# BULLETIN

Number: C0015      Date: 10/30/00      Supersedes:      Date:  
Title: 19XR5 Advisory  
Category: *GENERAL*      Termination Date:  
Author: Brice Auten  
Reviewed by: Alan M. Johnson  
Dept: CSS Service Engineering

Models      CAC: 19XR5 Compressors with Split Ring Diffusers  
Affected:      BDP:

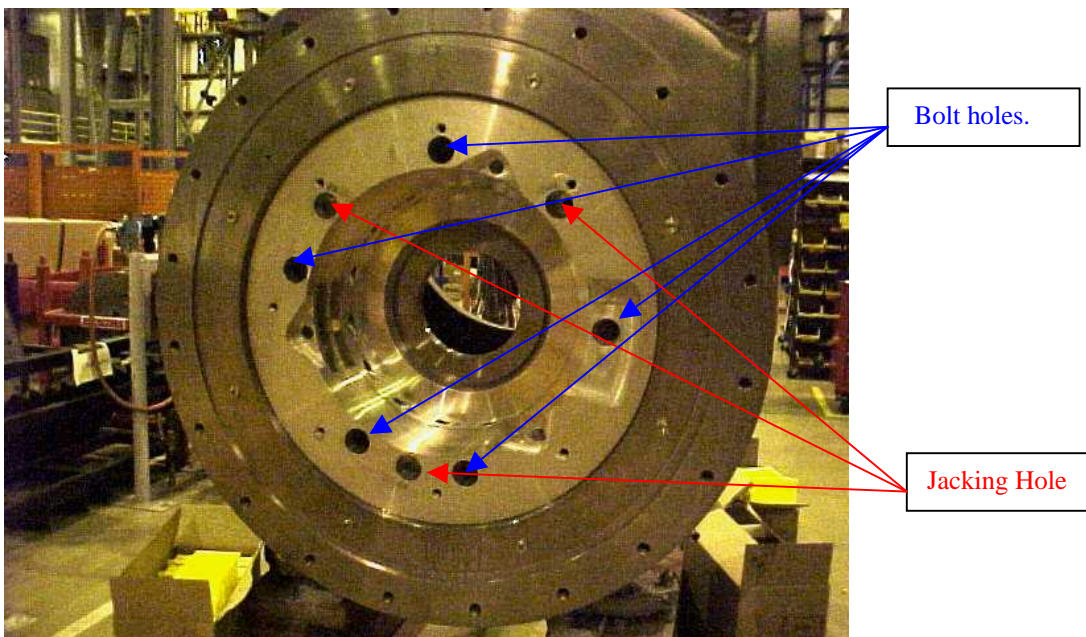
If the split ring diffuser is being removed for any reason, guide pins should be used to slide the assembly out just enough to get a sling around the assembly. These are guide pins only, not support pins for the 260 lb (118 kg) ring. The guide pins should be installed in the places where some of the bolts were removed. There are 5 bolt holes (deep) as well as 3 jacking holes (shallow) in the outer ring (see picture below). Until recently, there have been no indicators of which holes are for bolts and which are the jacking holes.

Starting with compressors built in week 41 (serial numbers 4100QXXXXX) the jacking holes are punch marked with a "JH".

If you put the guide pins in the jacking holes and pull the diffuser ring out, IT WILL FALL and could cause an injury. Make sure the guide pins are in an unmarked hole.

Any unmarked diffuser ring should be punch marked if it is opened for repair.
